CITY OF LA VISTA
MAYOR AND CITY COUNCIL REPORT
FEBRUARY 7, 2023 AGENDA

Subject:	Type:	Submitted By:
CHANGE ORDER NO. 3 – PARKING GARAGE NO. 1 AND NO. 2	◆ RESOLUTION ORDINANCE RECEIVE/FILE	PAT DOWSE CITY ENGINEER

Change Order

PROJECT: (Name and address)	CONTRACT INFORMATION:	CHANGE ORDER INFORMATION:
10-17105-40_La Vista City Centre Parking Garage No. 2 LaVista, NE	Contract For: General Construction Date: September 22, 2021	Change Order Number: 03 Date: January 17, 2023
OWNER: (Name and address)	ARCHITECT: (Name and address)	CONTRACTOR: (Name and address)
City of LaVista 8116 Park View Blvd LaVista, NE 68128	DLR Group inc. (a Nebraska corporation) 6457 Frances Street, Suite 200 Omaha, NE 68106	Sampson Construction Co., Inc. 5825 South 14 th Street Lincoln, NE 68512

10-17105-40
PLUMBING PLAN,
LEVEL 3

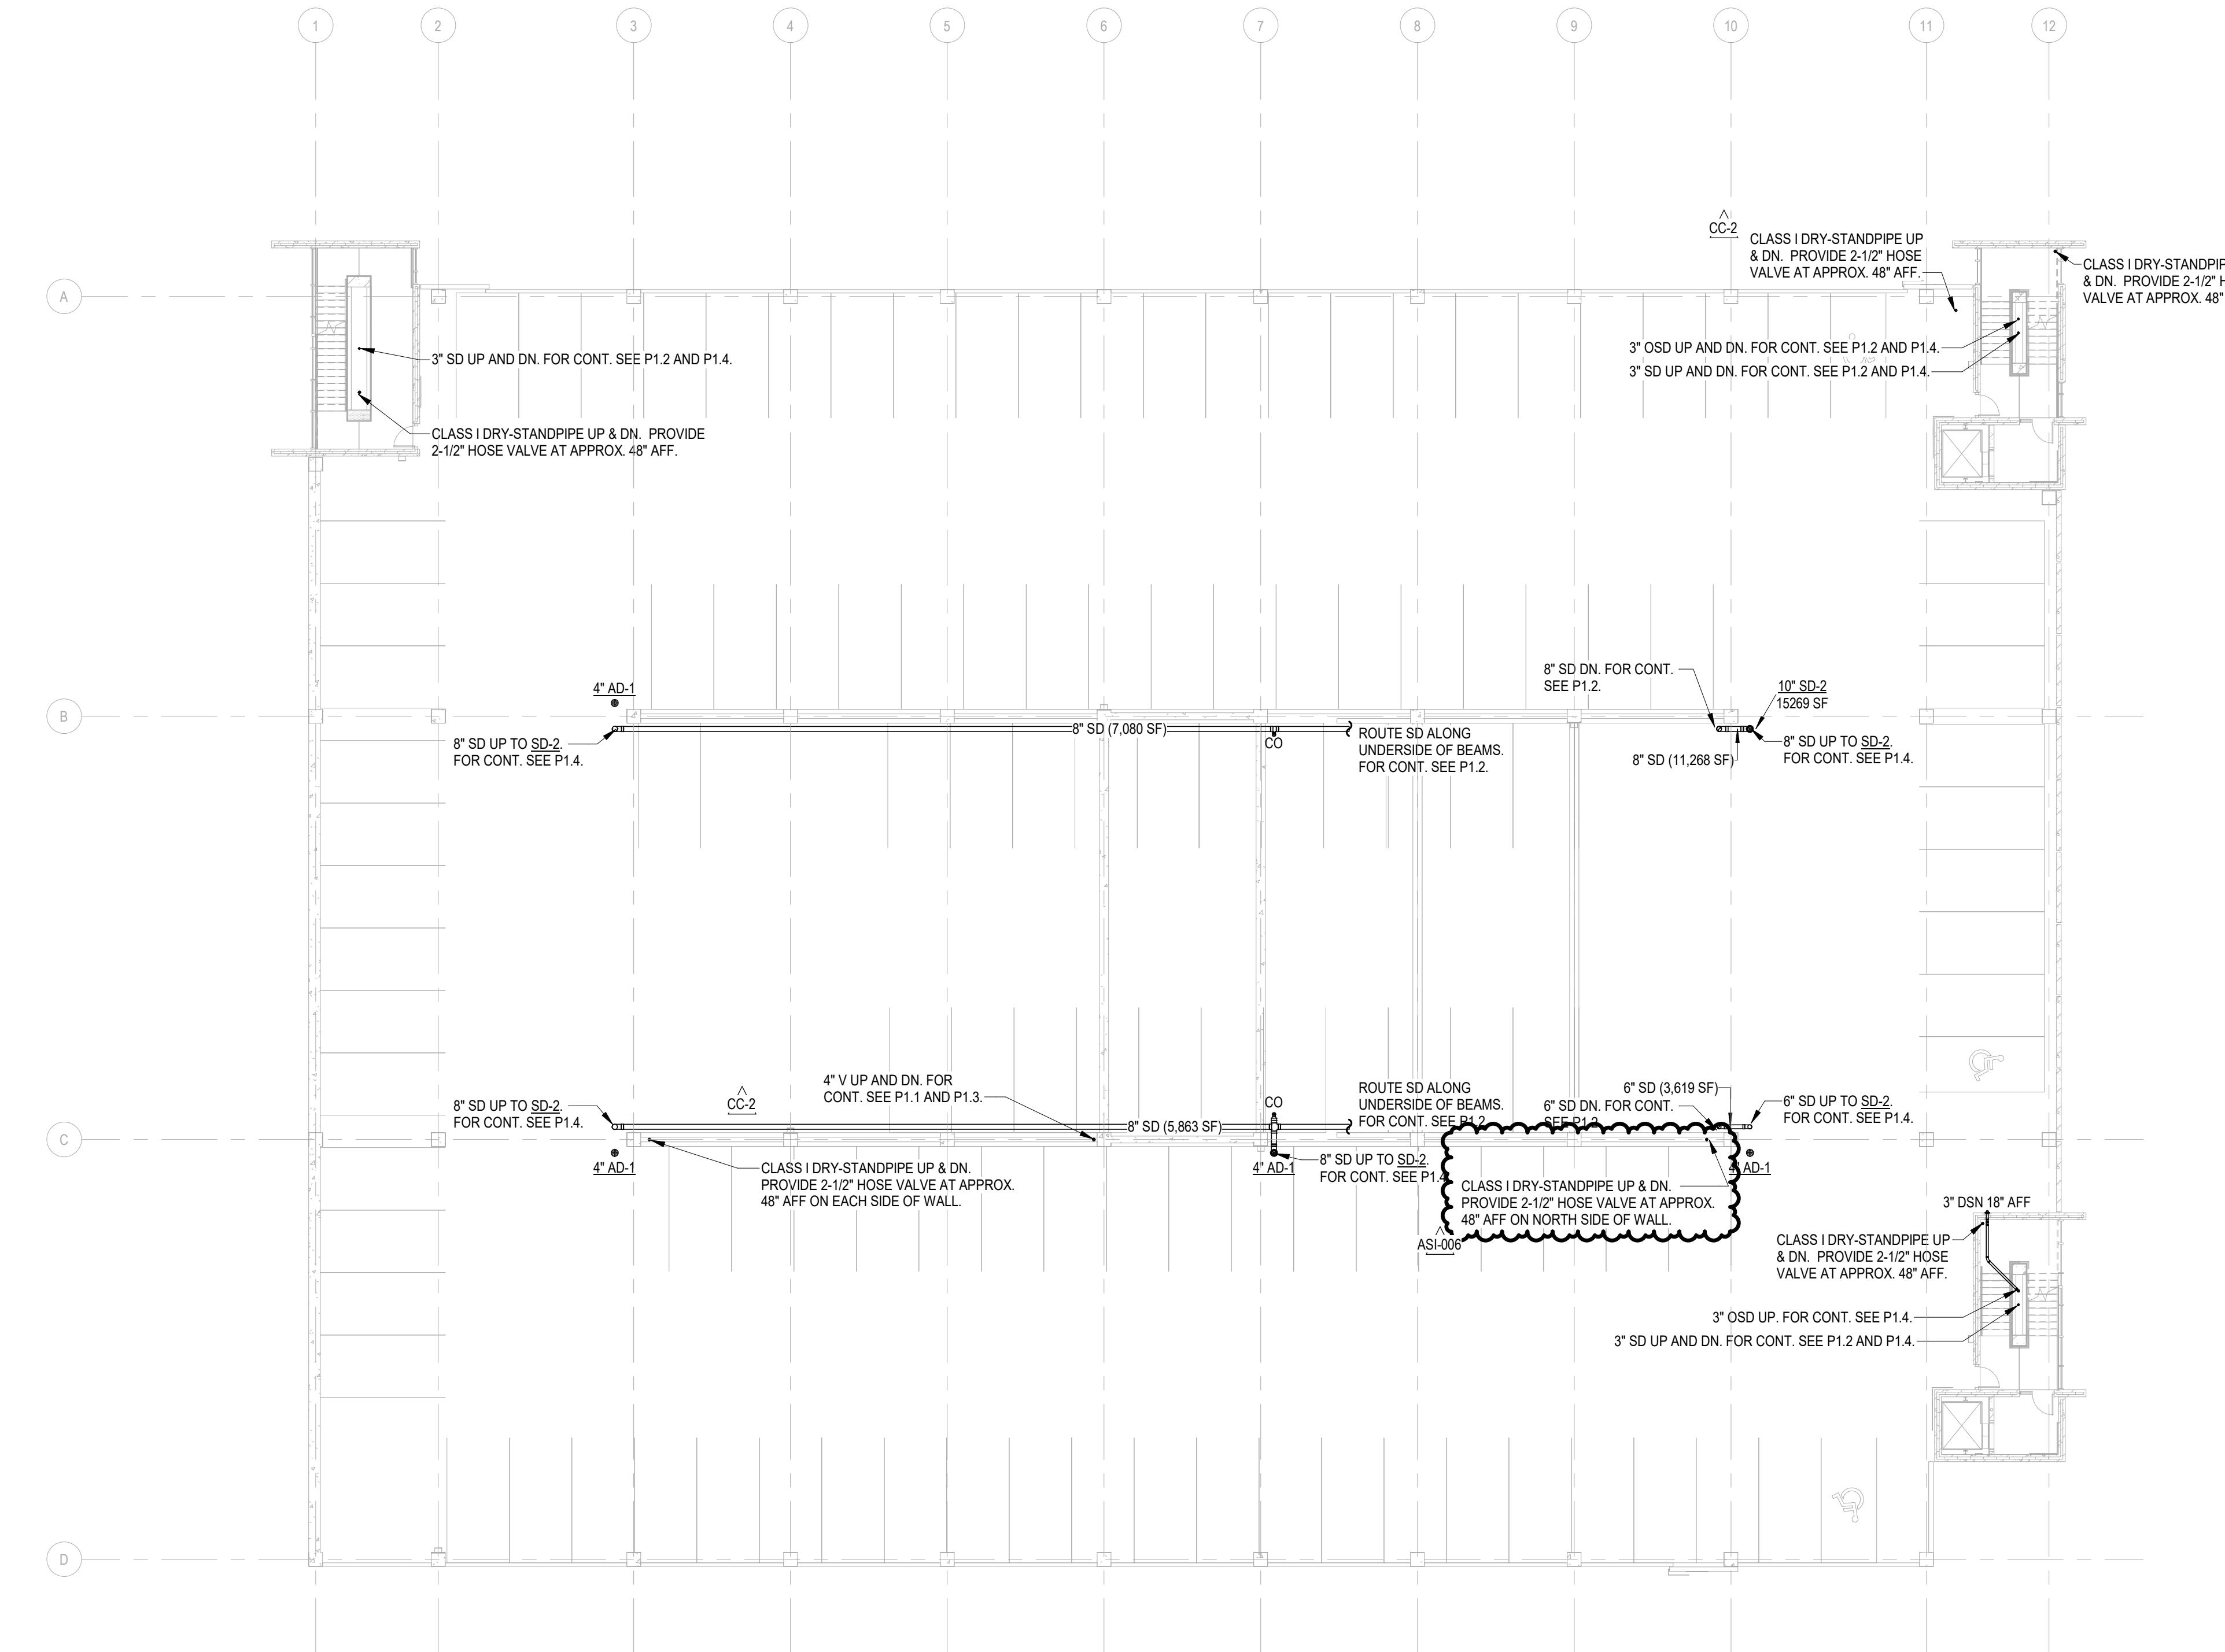
ITEM NO. 3. DRAWING P1.3 – PLUMBING PLAN, LEVEL 3

Mahoney Fire Sprinkler, Inc. tenders the following, in response to your request for changes in the base bid: Add Standpipe #6 and corresponding hose valves to the scope, per ASI-6.

A. Delete Drawing in its entirety and substitute new Drawing as shown on Attachment No. P1.3.

E6.1

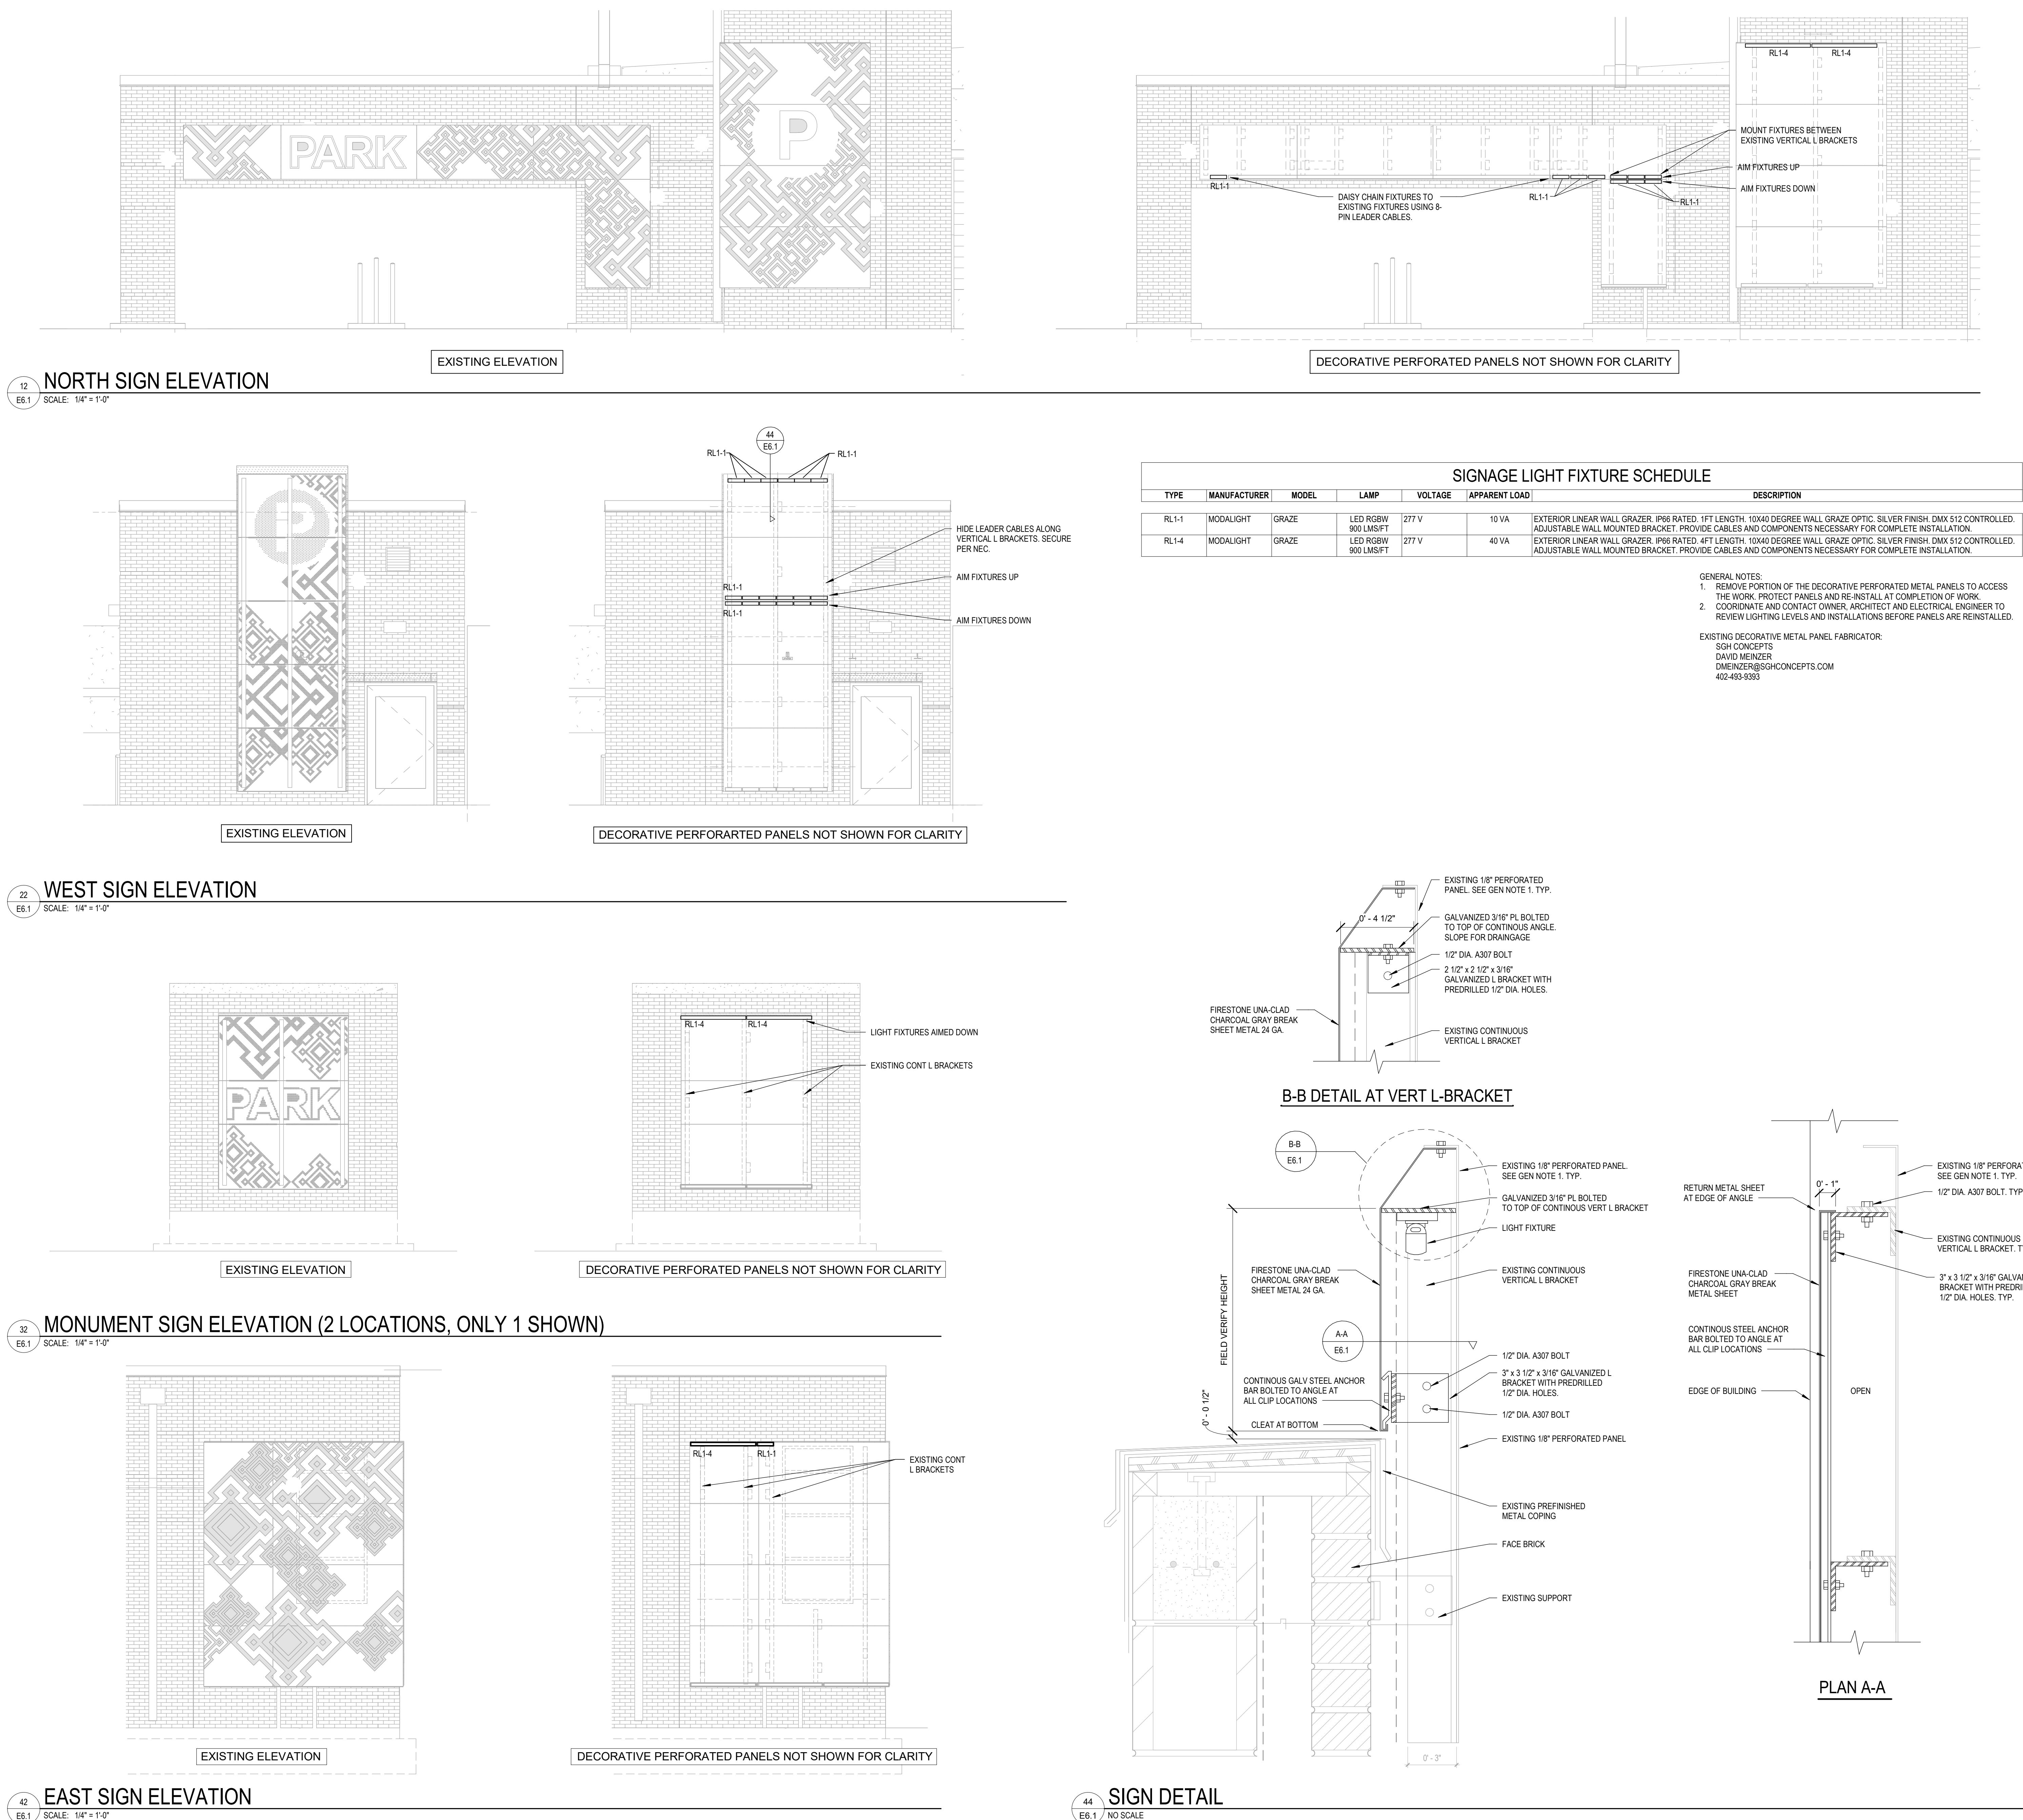
DESCRIPTION: Labor and material to add lights to Garage 1.

Title: Provide additional lighting at garage 1 as shown on sheety E6.1 This proposal does not include removal of existing perforated panels. **Date:** 8-Aug-22

- RL1-1 fixtures will be connected to existing fixtures using 1ft cords
- RL1-4 fixtures will be provided with one new DMX splitter / repeater and DMX signal will be derived from fixtures at entry

- RL1-1 fixtures added to existing fixture using 25' cable. No additional DMX splitter / repeater will be provided

- RL1-4 fixtures added connected to existing fixture using 25' cable. No additional DMX splitter / repeater will be provided

- RL1-1 and RF1-4 fixtures added connected to existing fixture using 25' cable. No additional DMX splitter / repeater will be provided
